Re: 5165Q – Supply and Delivery of Pool Air Handling Unit and Heat Recovery Ventilator - Addendum # 1

Watermania
 Richmond, BC
 AHU Upgrade
 Section 15966

**MECHANICAL
 EQUIPMENT SCHEDULES --
 POOL AIR HANDLING UNIT**

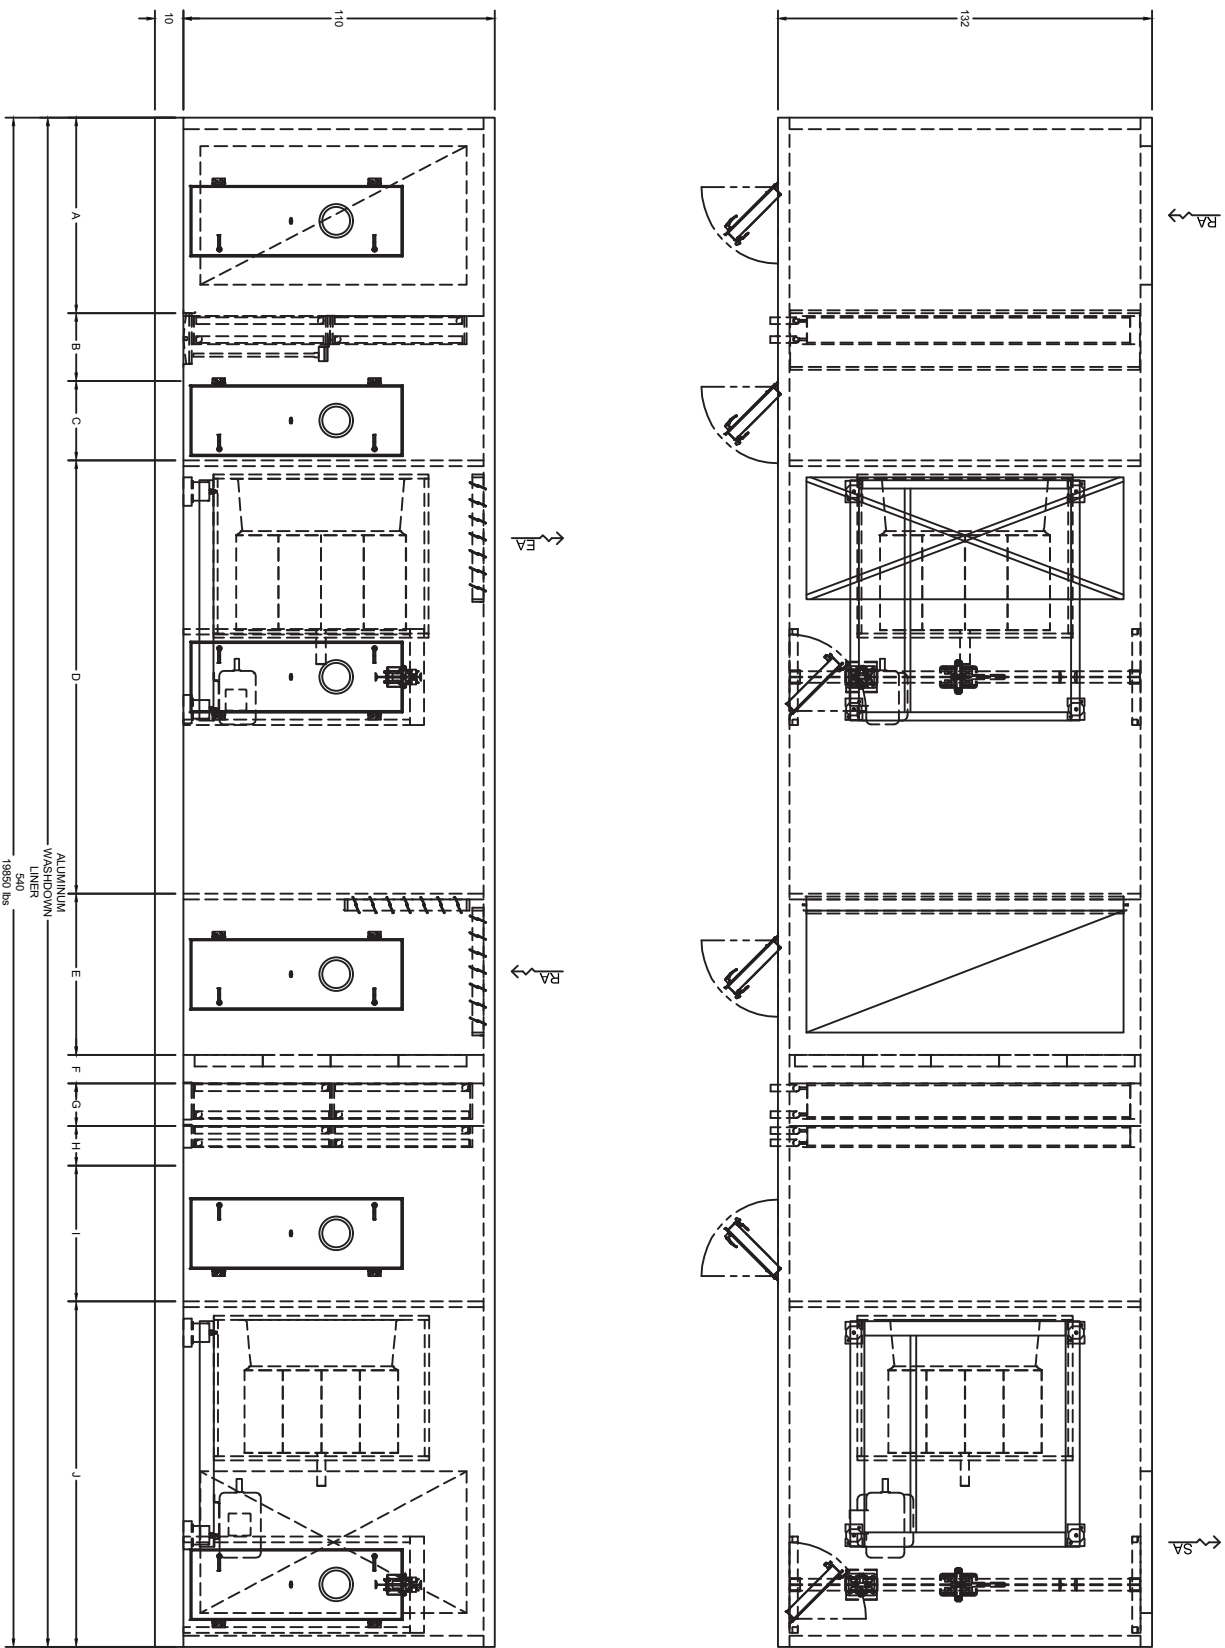
1. Revise: AHU-1 and AHU-2 performance specifications
 - 1.1. Cooling Coil and Reheat Coil #1 for both units have been revised
 - 1.2. Fan information revised – Belt Drive Fans
 - 1.3. VSD's are to be supplied by AHU manufacturer

2. Add: AHU configuration shall be as per the attached drawing.

SUPPLY	RETURN
AIRFLOW (L/s)	18880	19352
(CFM)	40000	41000
EXTERNAL (Pa)	375	312.5
STATIC PR (Inches)	1.50	1.25
FAN TYPE	VSD	VSD
DRIVE TYPE	BELT	BELT
FAN RPM	645	479
MOTOR HP	30	20
VOLTAGE/PHASE	600/3/60	600/3/60

COOLING (DEHUMIDIFICATION)	REHEAT (FROM HEAT RECOVERY UNIT)	REHEAT (FROM BOILER)
AIR FLOW (L/s)	18880	18880	18880
(CFM)	40000	40000	40000
TOTAL (kW)	367.8	268.8	220.1
CAPACITY (MBH)	1255.0	917.0	751.0
ENT AIR (Deg C)	26.7	26.7	8.9
(Deg F)	80.0	80.0	48.0
LEAVING AIR (Deg C)	15.6	38.6	40.0
(Deg F)	60.0	101.5	104.0
AIR FLOW (Pa)	165.0	145.0	47.5
PRESS DROP (Inches)	0.66	0.58	0.19
WATER FLOW (L/s)	10.84	15.75	5.17
(USGPM)	172.0	250.0	82.0
ENT WATER (Deg C)	8.9	40.6	82.2
(Deg F)	48	105	180
LEAV WATER (Deg C)	17.0	36.4	71.1
(Deg F)	62.6	97.6	160
WATER FLOW (kPa)	22.08	24.3	25.8
PRESS DROP (Feet)	7.36	8.1	8.6
# OF COILS	2	2	2
# OF ROWS	6	8	2

- 1) REFER TO MECHANICAL SPECIFICATION FOR DETAILS
- 2) VSD's SUPPLIED BY AHU MANUFACTURER
- 3) POOL QUALITY CONSTRUCTION W/ ALUMINIUM WASHDOWN LINER.
- 4) EPOXY COATING FOR CORROSION RESISTANCE
